Product Change Notification / SYST-210WVN419

ERRATA - PIC32MX1XX/2XX/5XX 64/100-pin Family Silicon Errata and Data Sheet Clarification

Added Silicon Issue 19. Module:Flash: RTSP

17. Module: I/O Port - Initial Pin State

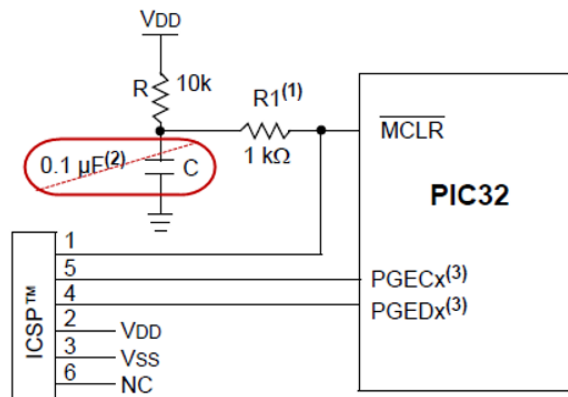
On power-up depending on the VDD ramp rate, the I/O pins can be in an active random output driving state if $\overline{\text{MCLR}}$ is active until a BOR event.

If, not using an external reset supervisor IC or equivalent, remove the $\overline{\text{MCLR}}$ capacitor as shown below, and retain the $\overline{\text{MCLR}}$ Pull-up resistor.

If using an external reset supervisor IC or equivalent, increase the value of the VCAP capacitor to $\geq 47 \mu\text{F}$ ceramic or solid tantalum capacitor with an ESR $\leq 1 \text{ ohm}$.
